**ADDENDUM  
NO. 02**

**March 14, 2022**

**Warren Central High School Phase 3 Renovation and Addition  
9500 E. 16<sup>th</sup> Street  
Indianapolis, IN 46229**

This Addendum consists of Pages ADD 2-1 through ADD 2- 5, and attached CSO Architects Addendum No. 2 , dated March 13, 2023, consisting of 11 Pages, Specification Section 02 01 00 – Maintenance of Existing Conditions, and Addendum 2 Drawings: C101, C102, C401, C501, C502, C503, LD001, L101, L106, L201, L206, L301, L306, S201PRT, S202PRT, S501, S601, AD201N, A201M, A201N, A202N, A211G, A211M, A211N, A401, A404, A423, A431, A432, A600, A601, A602, A603, A611, A612, A701, A702, A703, A800, A801F, A801J, A801M, A801N, A801P, A801R, A801T, A802F, A802N, A802P, A802R, A802T, A900A, A900B, A901K, A902U, A903, A904, A905, A906, MD201F, MD201H, MD201J, MD201K, MD201L, MD202HJ, MD202N, M201F, M201J, M201K, M201L, M201N, M202HJ, M202N, M211F, M211H, M211J, M211K, M211L, M211N, M212HJ, M301, M303.

3.56 SHEET A903 – CASEWORK ELEVATIONS

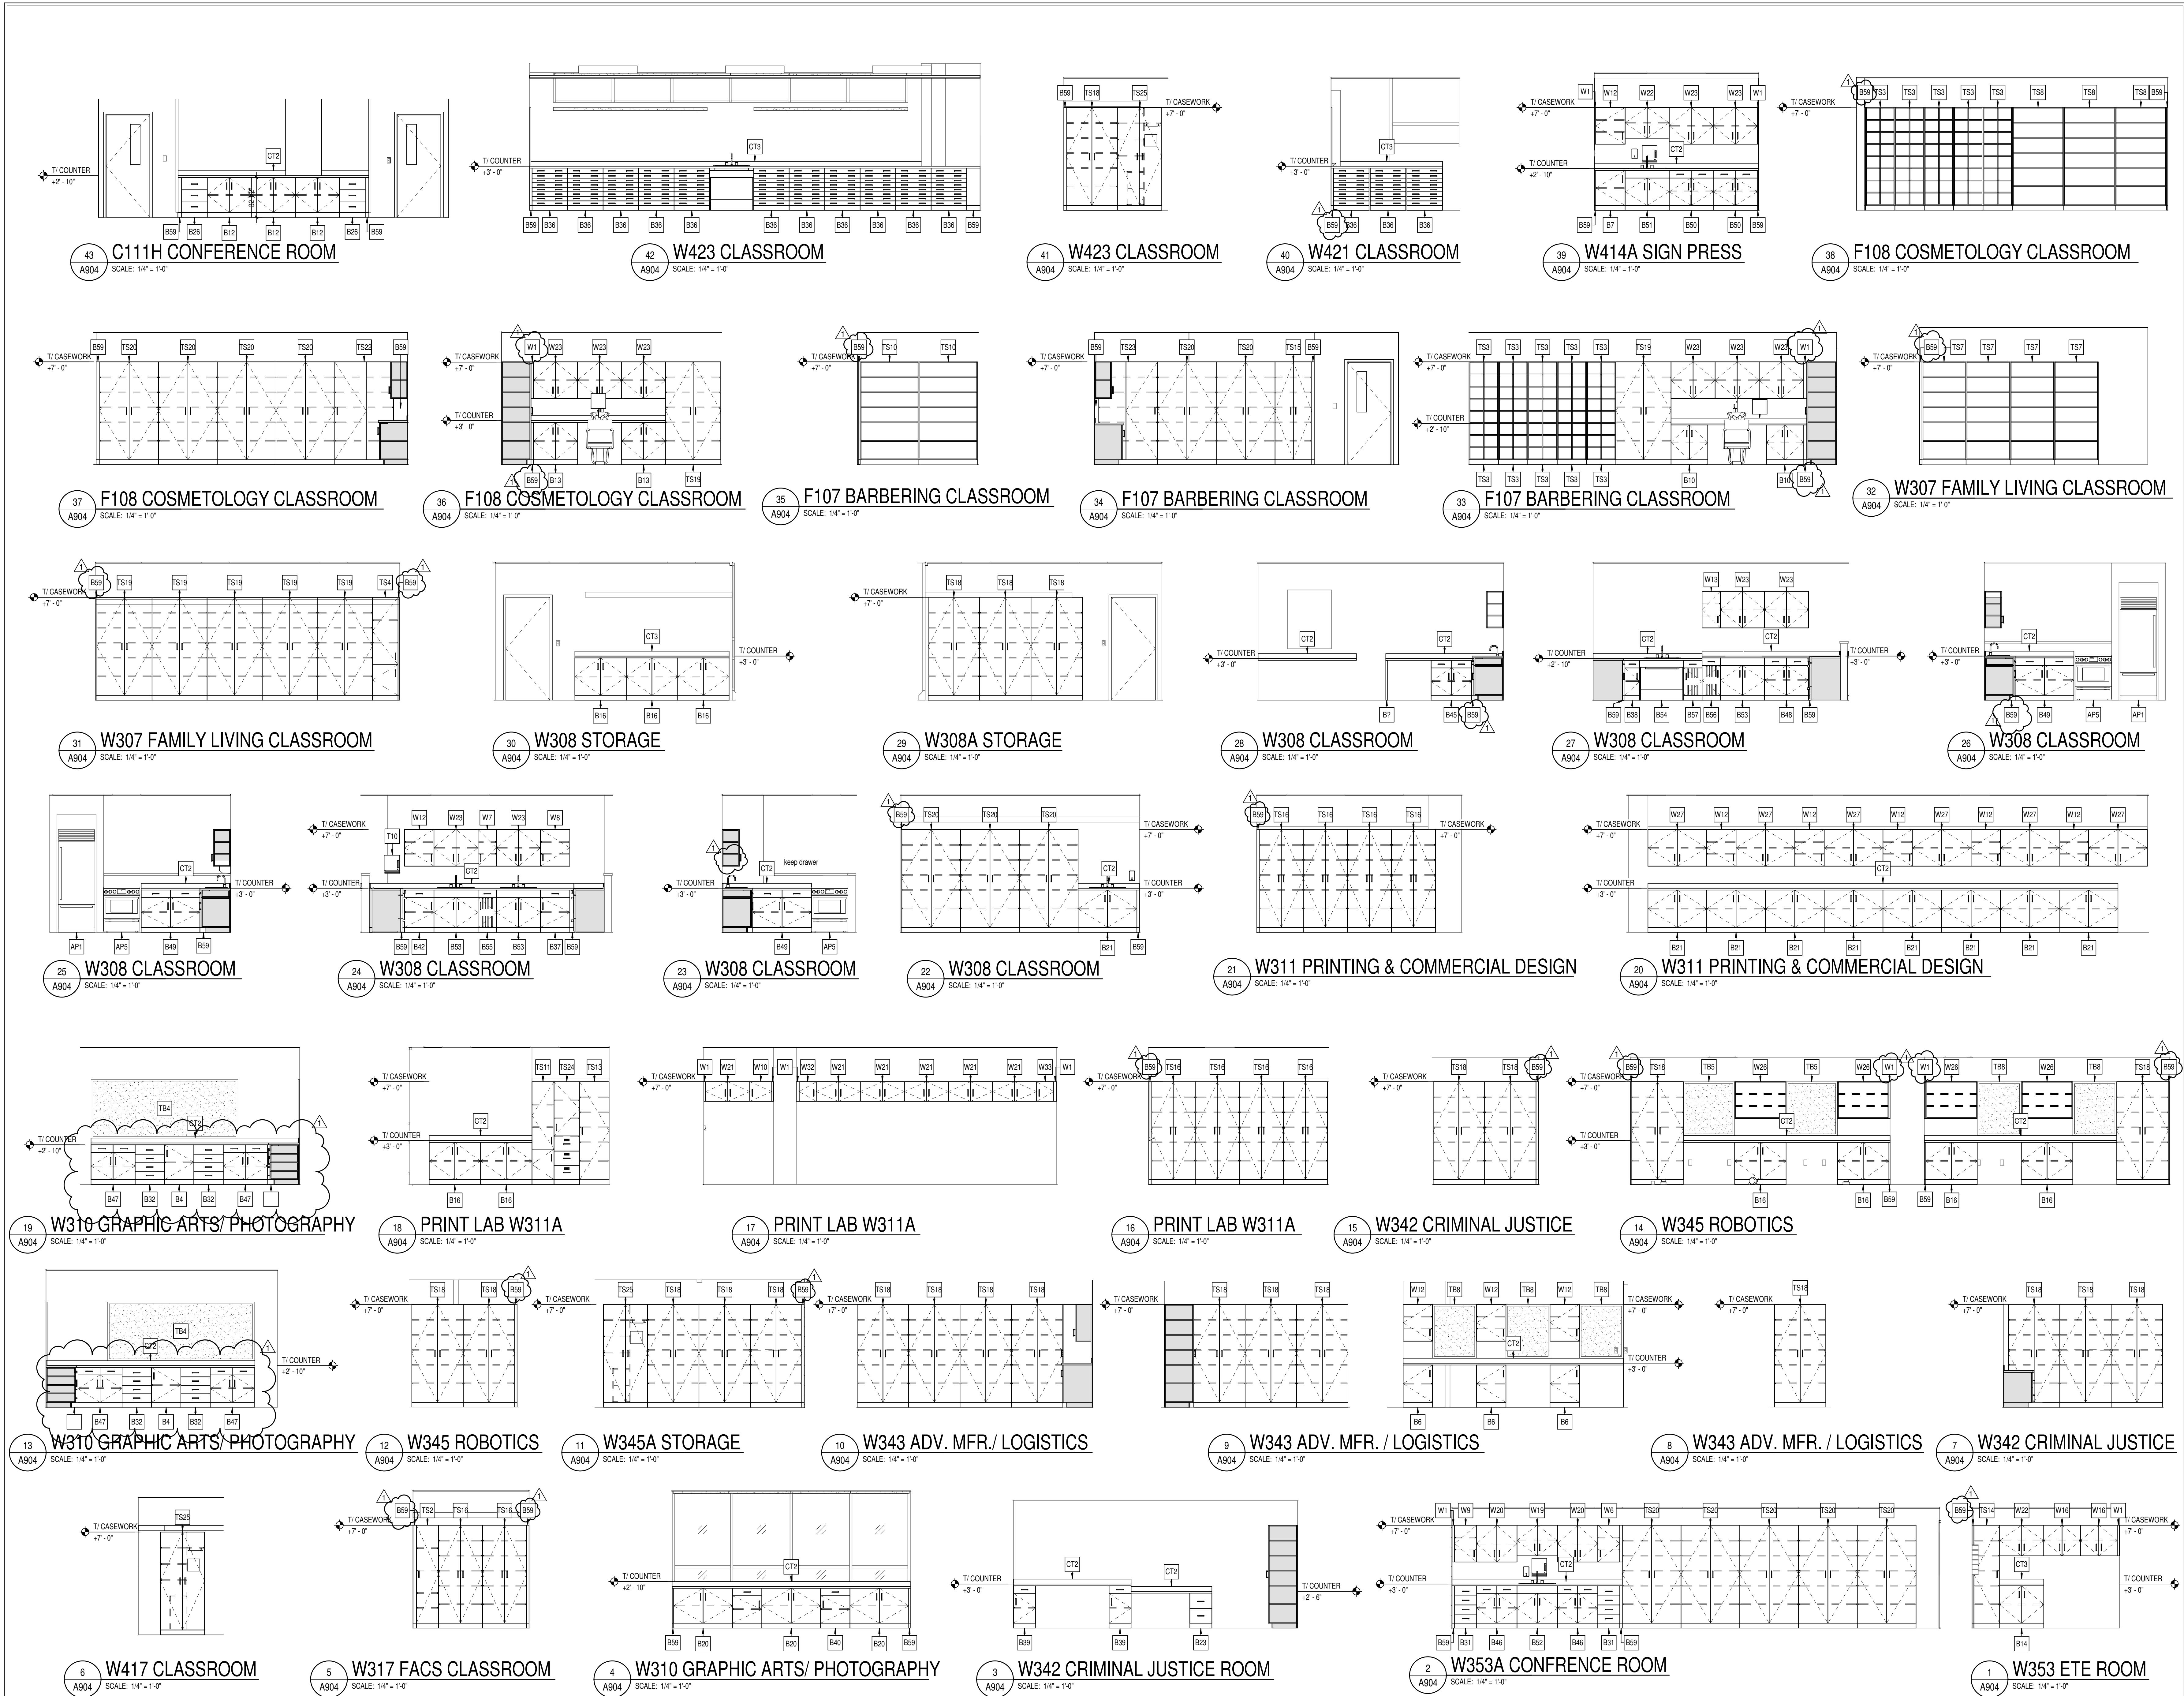
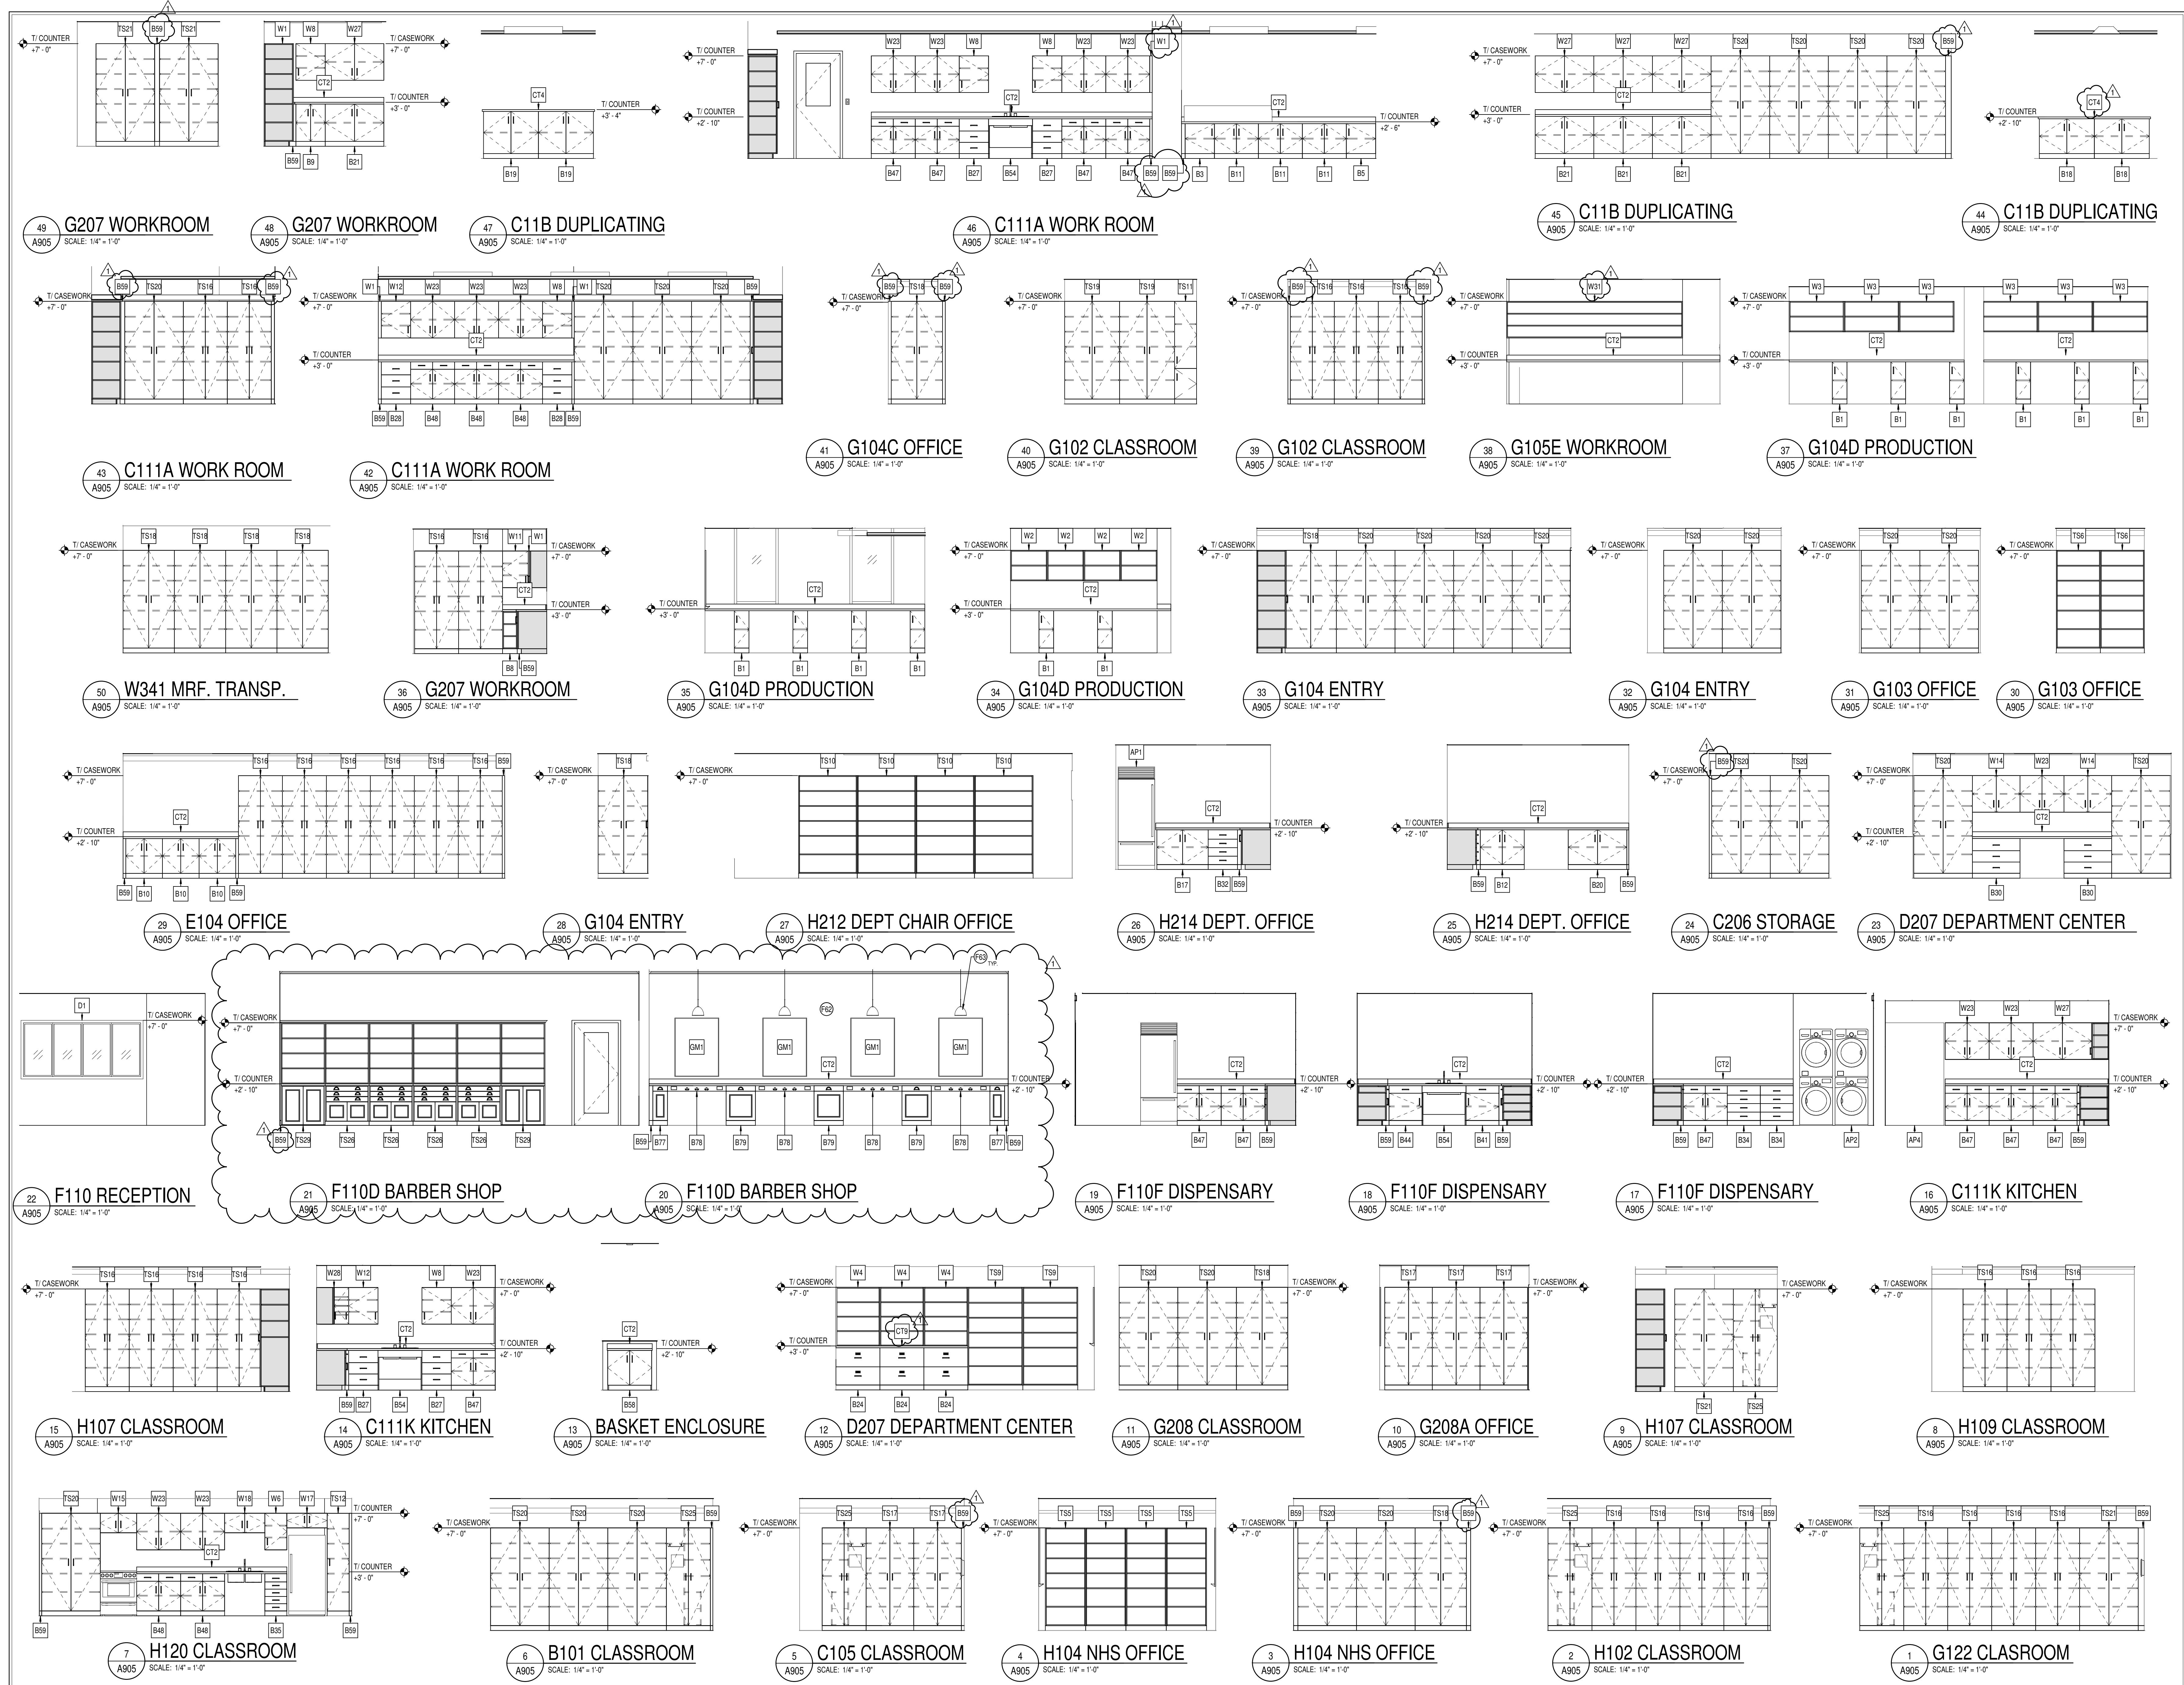
- A. REVISE interior elevations as indicated on attached, re-issued Sheet A903.
